Subject: Rice Solar Energy Project (09-AFC-10)  
Response to CEC Staff Workshop Query 13

**Response to CEC Staff Workshop Query 13**

**Rice Solar Energy Project**

**FIGURE WSQ13-1**  
**FIBER-OPTIC CABLE ATTACHMENT**  
**ALTERNATIVES, PARKER-BLYTHE**  
**161 KV TRANSMISSION LINE**

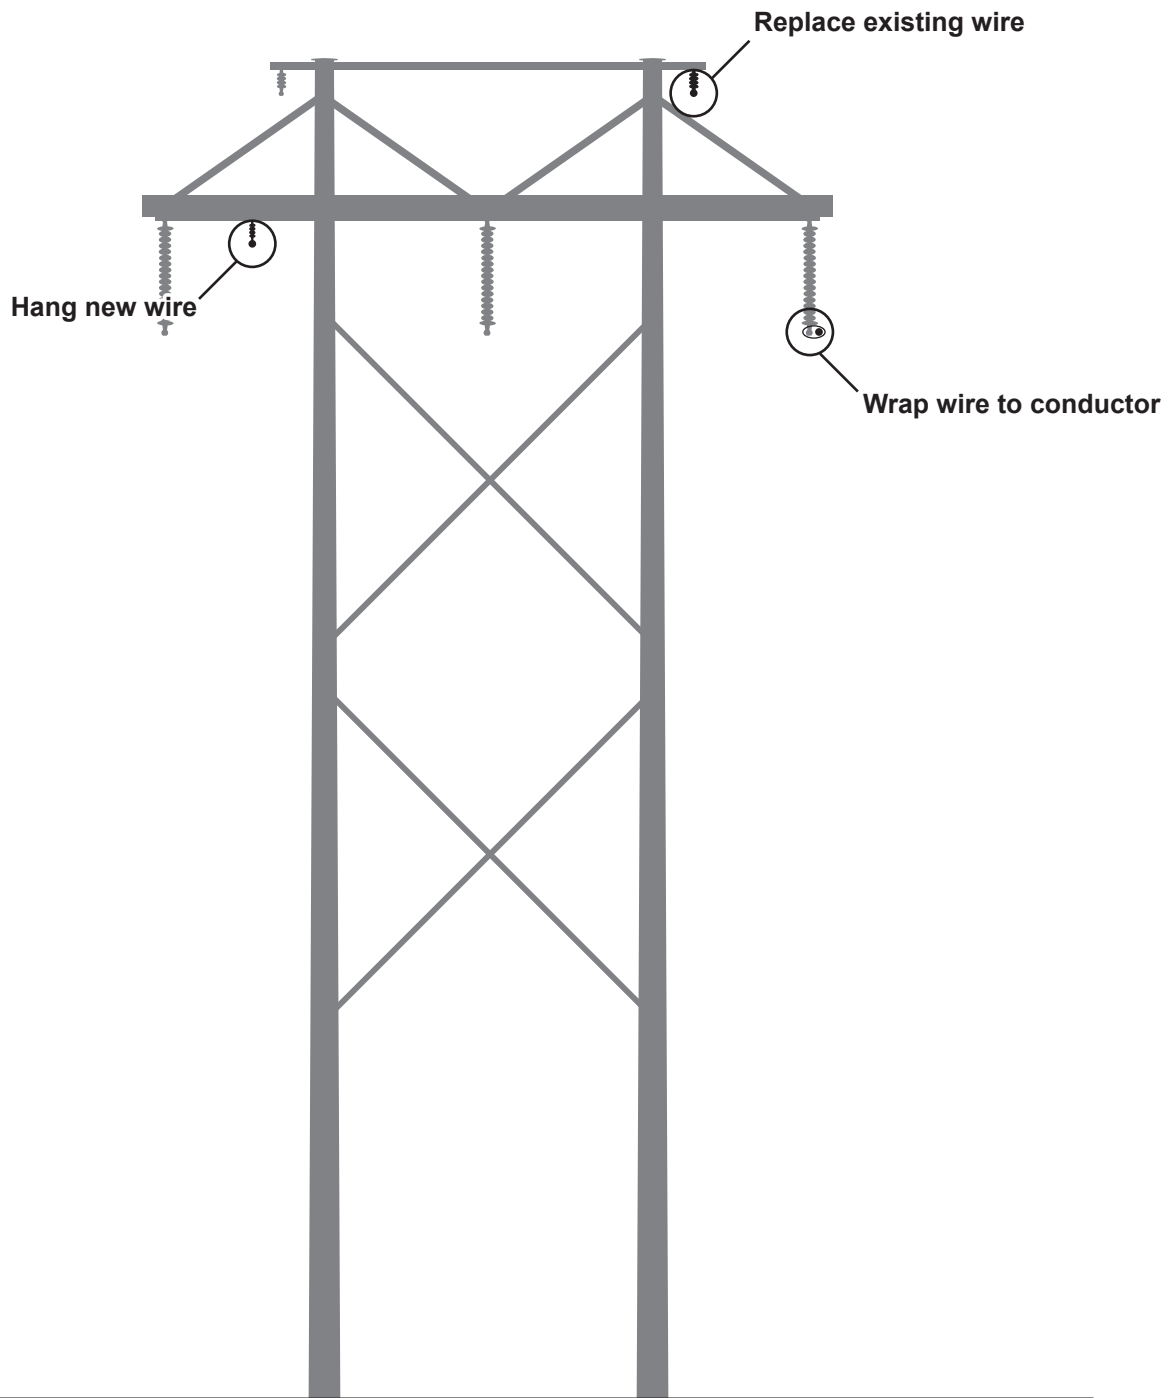
WSQ 13      *Please provide a description of the communication system that may be required to provide communications between the new substation at the interconnection with the Western's existing Parker-Blythe #2 Transmission Line and other Western facilities.*

The optical wire would be incorporated with the existing Parker-Blythe #2 161 kV line using one of three methods: (1) OPGW installed as a replacement to one of the existing OHGW wires, (2) ADSS hung from the poles beneath the existing high-voltage conductors, or (3) optical cable wrapped directly onto one of the OHGW or high-voltage conductors. Currently, it is anticipated that Western would require installation of a new OPGW in place of one of the existing OHGW wires, as the two other methods are not presently sanctioned by Western. Figure WSQ13-1 is a sketch of a typical cross section of the existing Western transmission poles, indicating positions where the new optical wire may be mounted in either the OPGW, ADSS, or wrapped-on-conductor method.
